**Project #22-040  
Homestead Commercial Building Revision  
Located at approximately 650 West 400 North**

*Project Name:* Homestead Commercial Building Revisions  
*Proponent / Owner:* Klair Fullmer / 200 North Land Holdings LLC  
*Project Address:* 650 West 400 North  
*Request:* Design Review  
*Current Zoning:* Mixed Use (MU)  
*Type of Action:* Quasi-Judicial  
*Hearing Date:* July 28, 2022  
*Submitted By:* Russ Holley, Senior Planner

Staff recommends that the Planning Commission **conditionally approve** a Design Review Permit for Project #22-040, Homestead Commercial Building Revisions, in the Mixed Use (MU) zone located at approximately 650 West 400 North., TIN #05-127-0003

Figure 1 shows the site plan

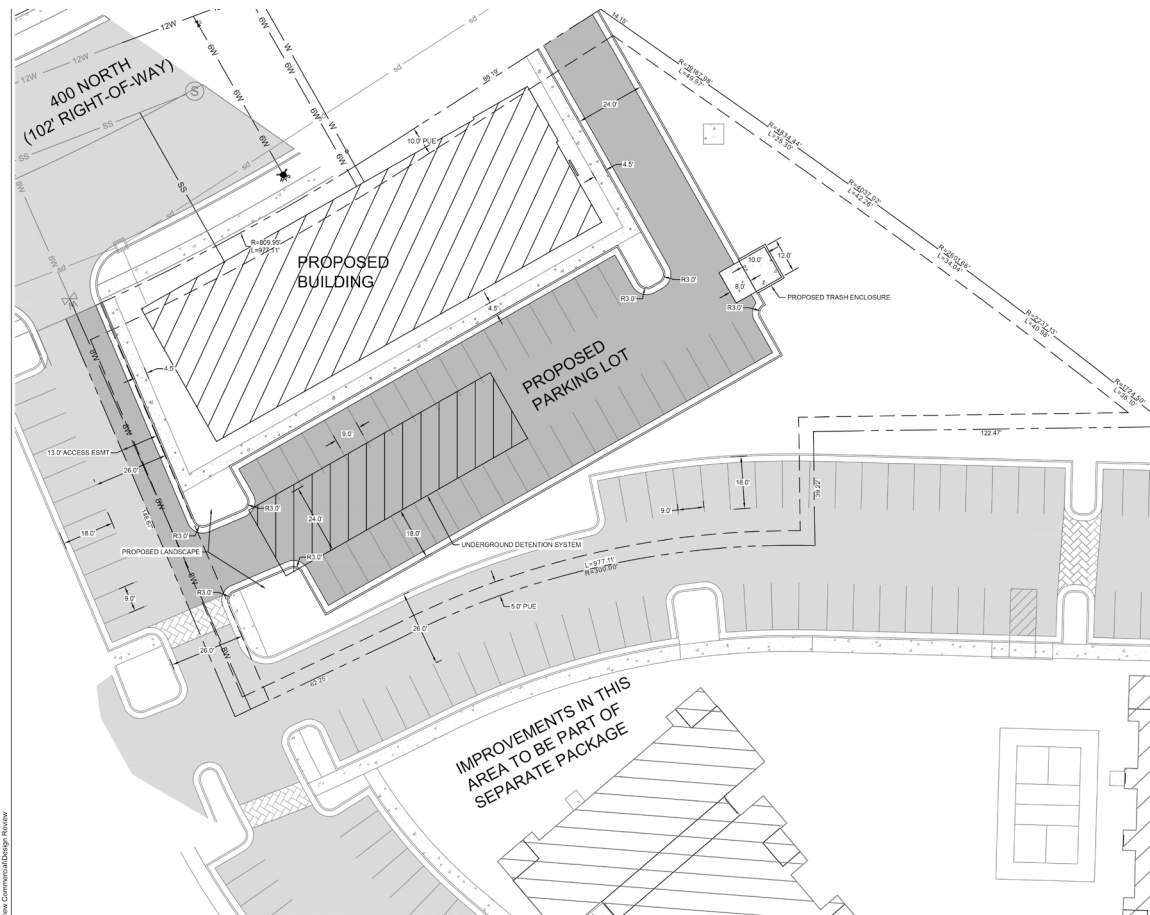
The LDC 17.30 require projects to provide pedestrian circulation and street connectivity. The proposed site layout and pedestrian circulation shows a new sidewalk connection from 400 North to the building entrances. The plan shows a small missing gap between the sidewalks

connecting the other Homestead residential areas and this building near the west side of the site. As conditioned with this missing sidewalk gap being installed, the project complies with the pedestrian circulation requirements in the LDC.

4. The site shall have a bike rack installed prior to occupancy.
5. The missing sidewalk gap connecting the residential areas to the south to the commercial building shall be filled so that a complete pedestrian sidewalk network connects throughout the site and to 400 North.

Figure 2 shows the proposed front and rear facades (North and South)

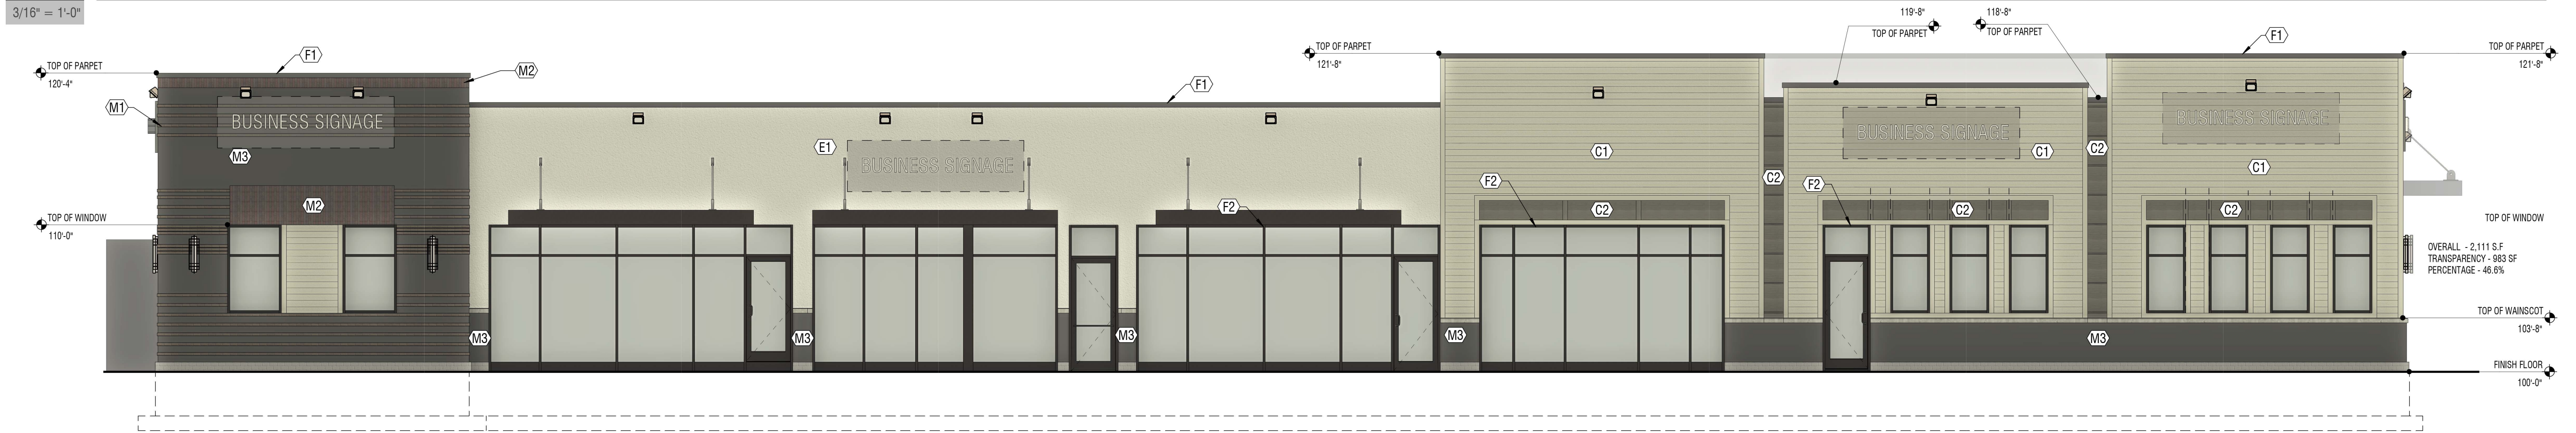
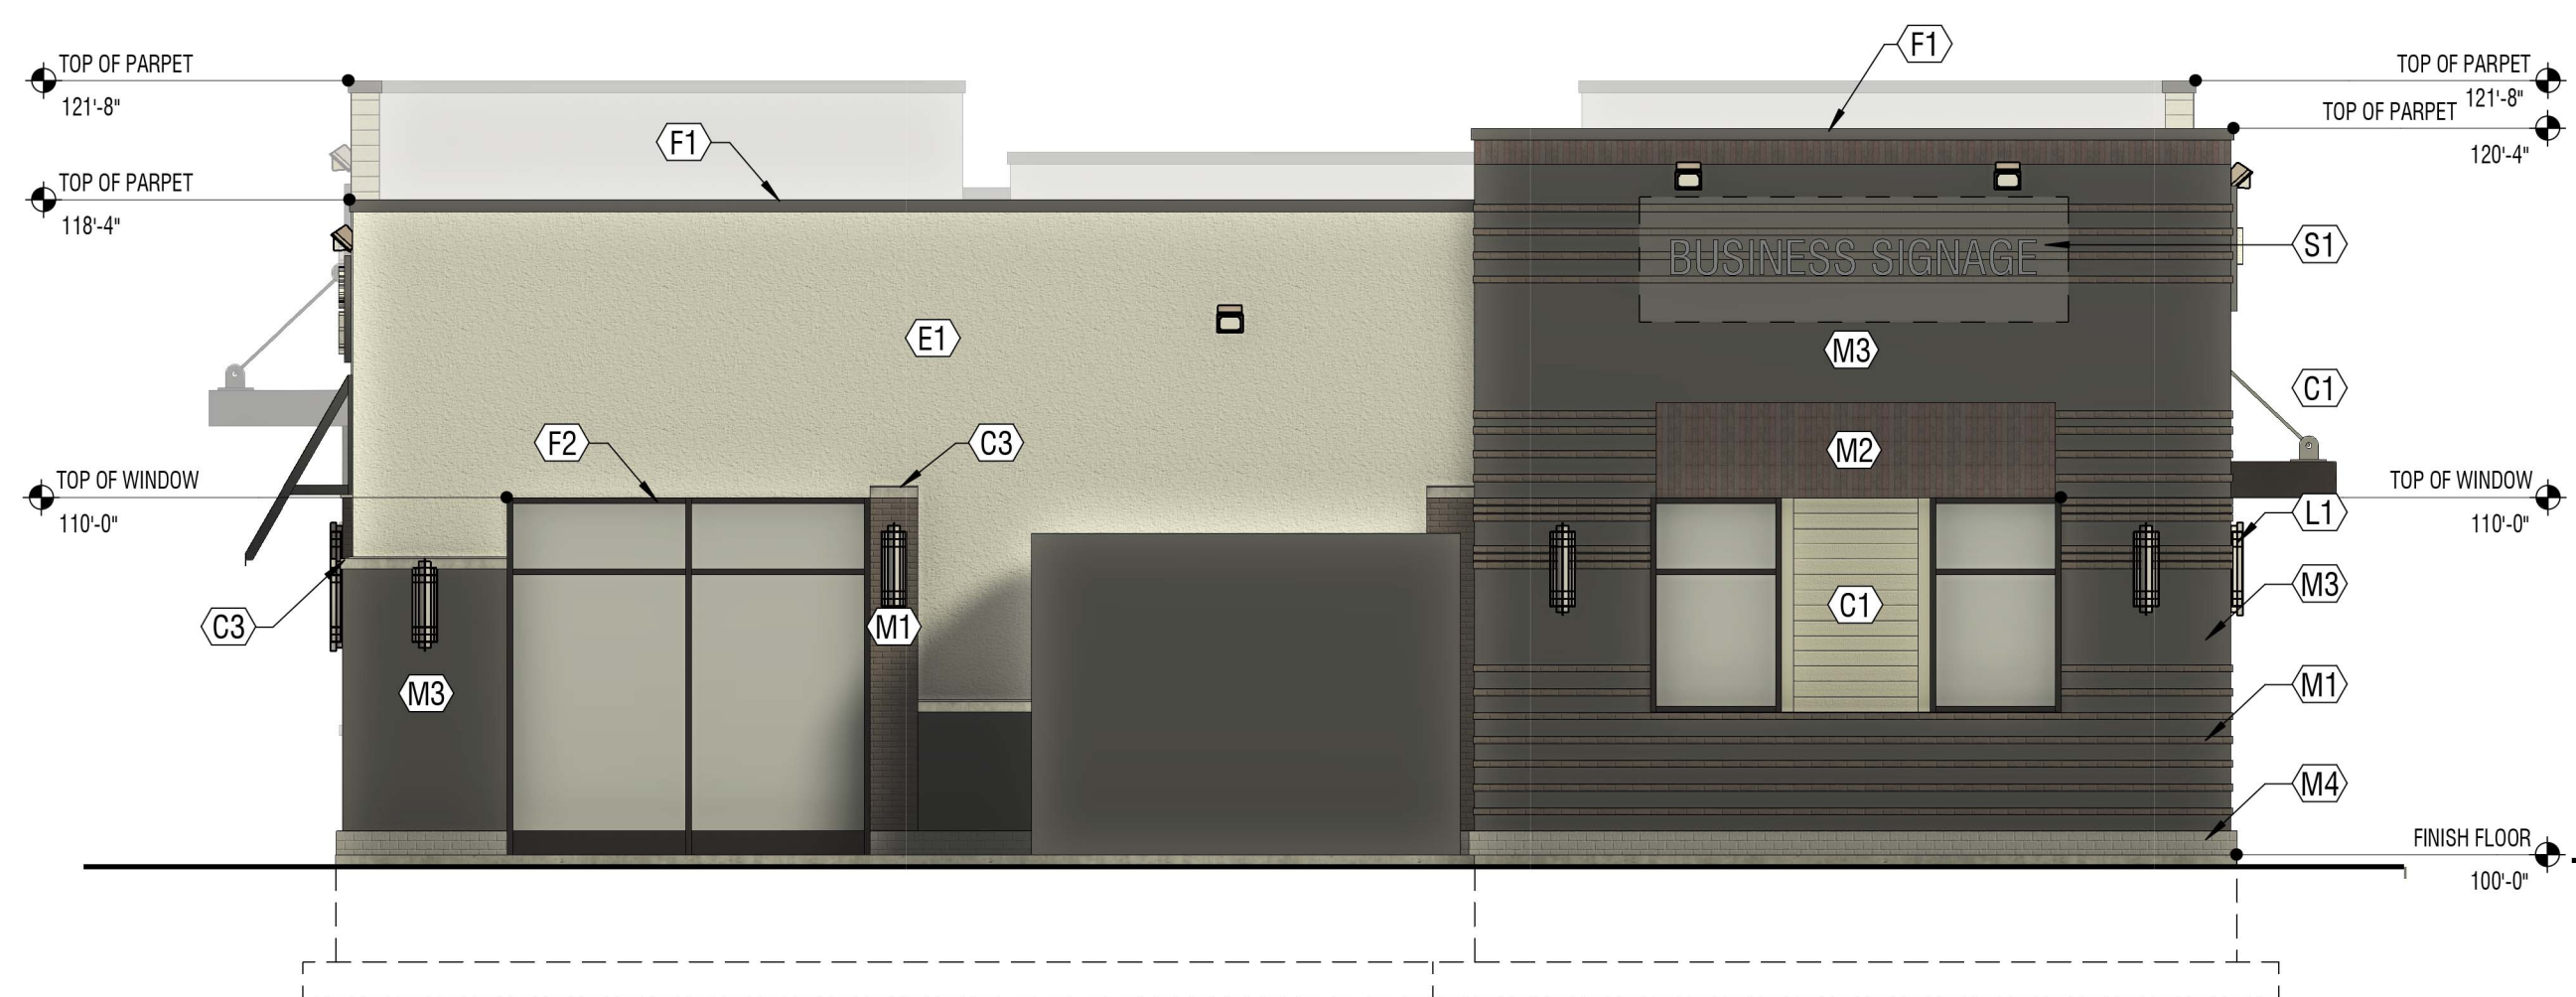
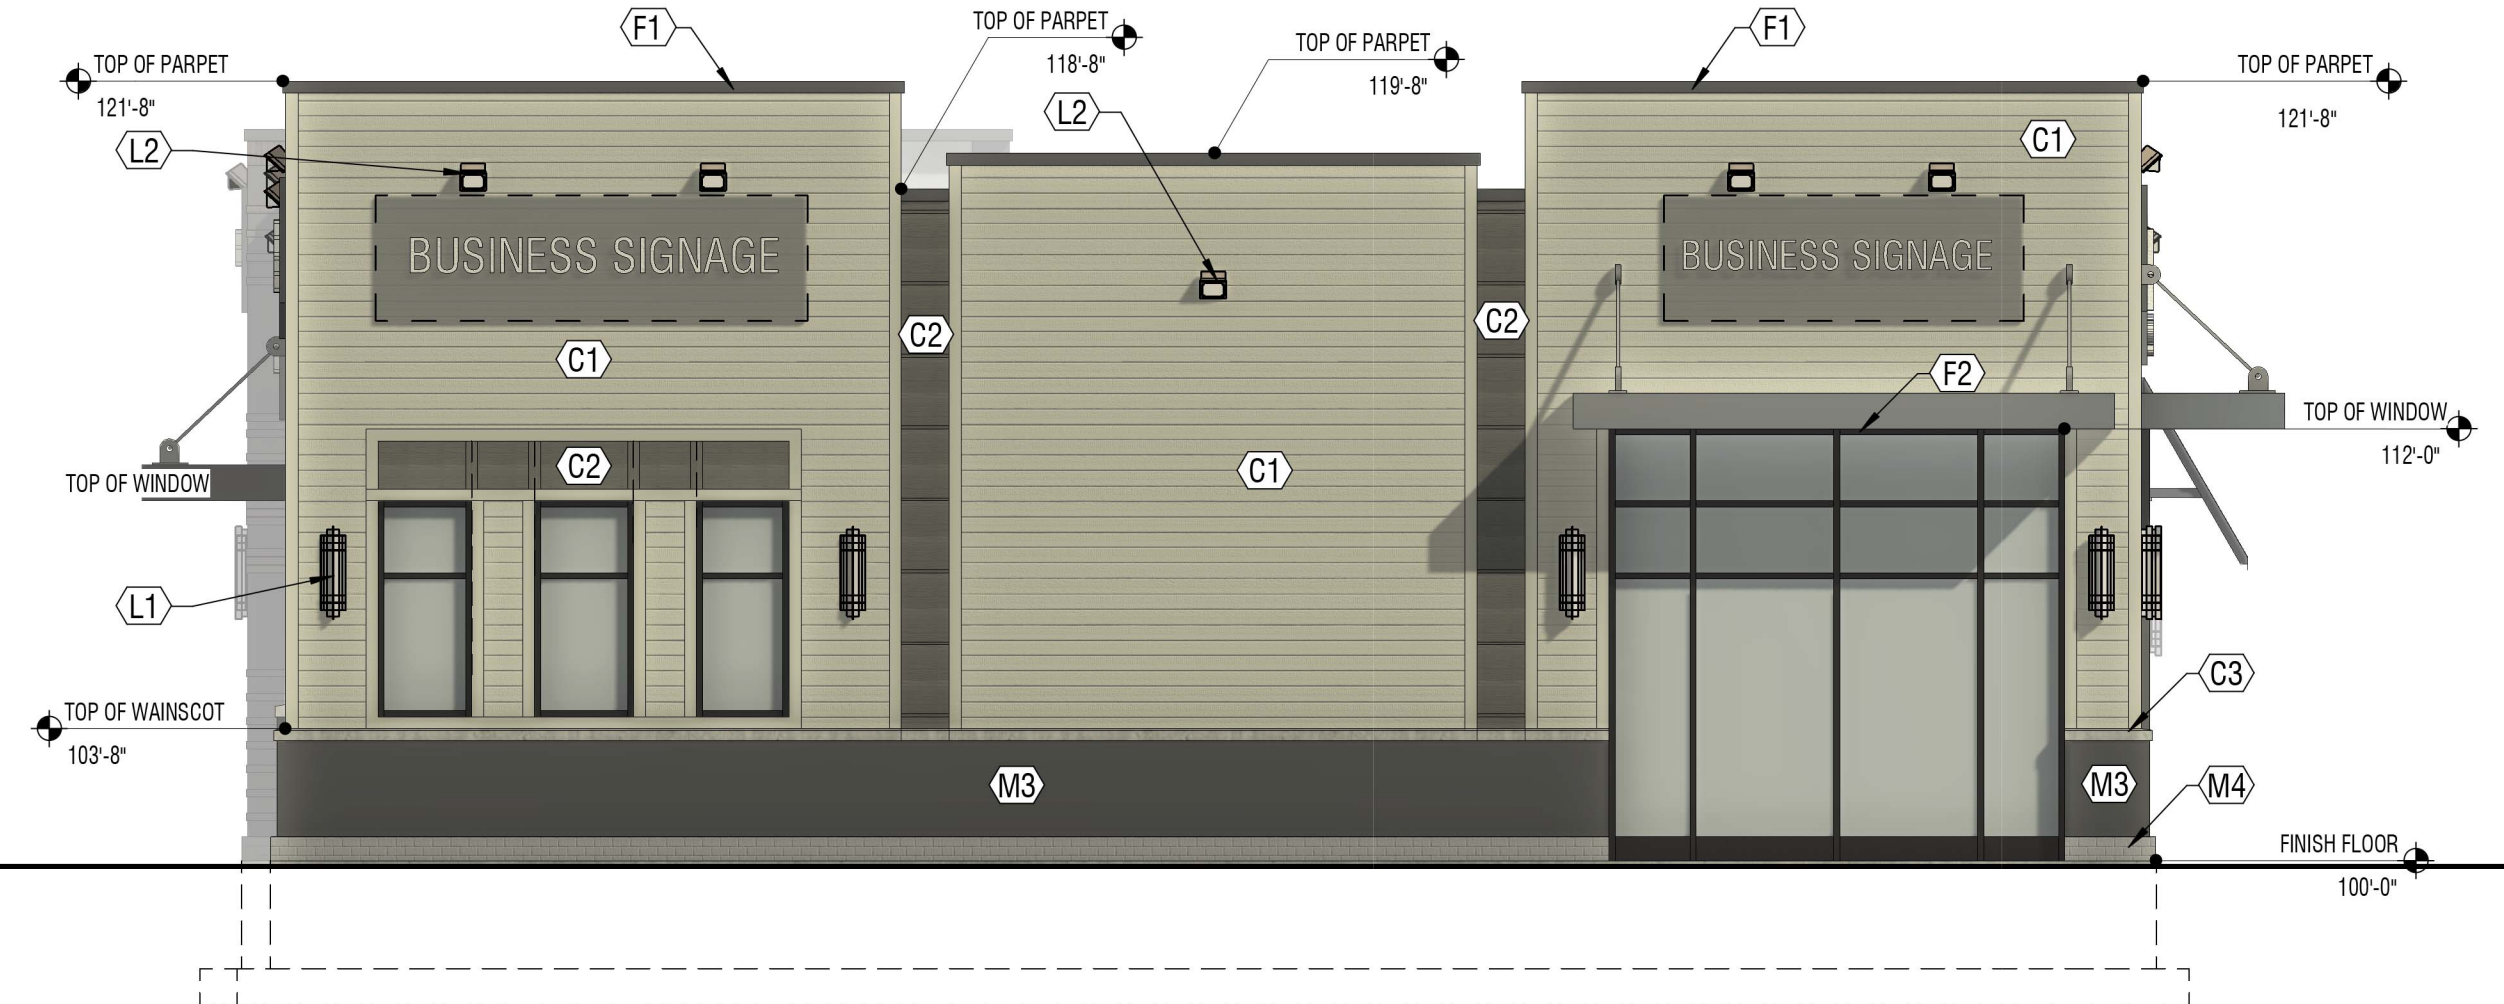
The LDC 17.12 indicates that buildings in the MU zone shall have four-sided architecture and a mix of materials. Acceptable building materials are masonry, stucco, fiber-cement board, wood and metal. Material mixes shall wrap all four sides of buildings and blank walls exceeding 40 linear feet are prohibited. Vertical dimensions of blank wall shall not exceed 12 feet and roof forms should be varied for visual interest. Buildings should be oriented to the street with primary entrances. Alternatively, in cases where the primary entrance is not facing the street, the street facing façade shall closely mimic that of the primary entrance façade. Surface parking lots are prohibited between the street and the building (front yard areas) and required to be at the side or rear of the building. Commercial/Mixed Use buildings are required to have 50% transparency (fenestration) along ground-floor street frontages. As proposed the building design shows four-sided architecture, a mix of materials and minimal blank wall areas. Excluding the parapet, the street facing façade is shown at 50% transparency. As submitted, building designs meet the LDC requirements.

6. The building design and materials are approved as submitted.
7. Surface parking lots cannot contain more than 20 stalls in a row without a landscape or sidewalk break as per LDC 17.31.140 Change to reference 17.32.070 instead of 17.31.
